From: Cris Simpson *cris.simpson@intel.com*
Date: March 21, 2002
Title: LOGOUT signals: Model concerns

Recent discussions within the SRP WG have suggested the need for a “logout signal”, allowing certain resources to be released by targets and logical units. Defining this signal requires a model for what it does and does not do. Clause 2 introduces new concepts to support the signal, and highlights some apparent problems with the current direction. Clause 3 includes some material from SAM-2, with comments.

Figure 1: Proposed Interconnect Port Model

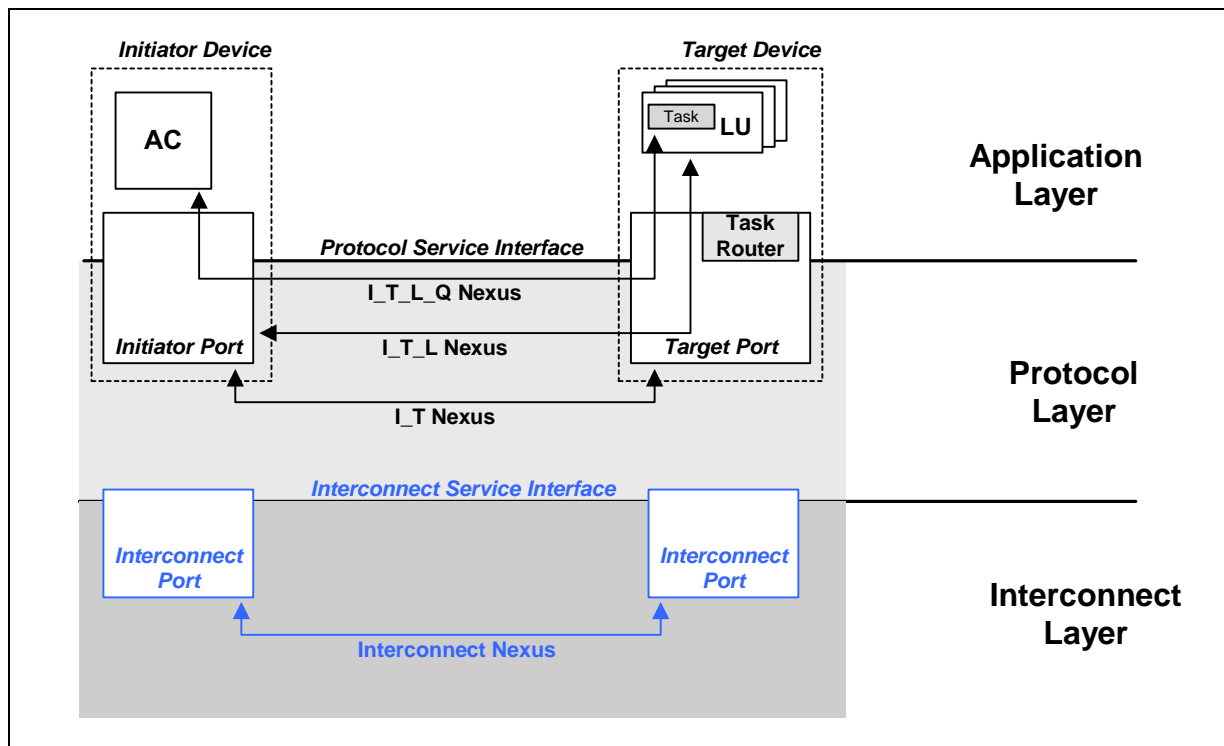
A complete ‘logout signal’ mechanism must consider the interconnect layer, not currently discussed in SAM-2. The figure introduces *interconnect ports*, which serve as the connection between the protocol and interconnect layers. The association of two interconnect ports is called an *interconnect nexus*, paralleling

SRP supports a multi-channel mode in which multiple INs form a single I_T nexus, but when one of the INs is disestablished, all tasks delivered to the target over that IN are to be aborted. This suggests the need for another signal, INTERCONNECT NEXUS LOST. This signal would be sent from the interconnect port to its associated SCSI (initiator or target) port. This is distinct from the proposed LOGOUT signal, which presumably would be generated when the last IN of an I_T nexus was disestablished. (This could be confusing for SRP because SRP_LOGIN_REQ and SRP_X_LOGOUT_REQ, in multi-channel mode, add/remove INs from the I_T nexus.)

Figure 5 — Client-Server model

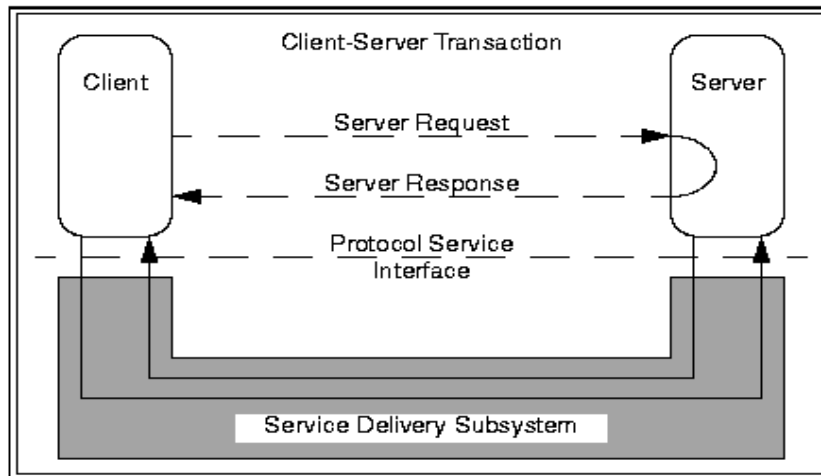
Here, the Service Delivery Subsystem is the stuff below the Protocol Service Interface (i.e., Protocol and Interconnect layers).

Figure 10 — Service delivery subsystem model

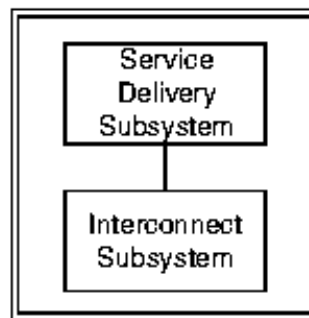
The service delivery subsystem connects SCSI ports (see 3.1.94) and is composed of an interconnect subsystem (see figure 10). "composed of" implies *exclusively*.
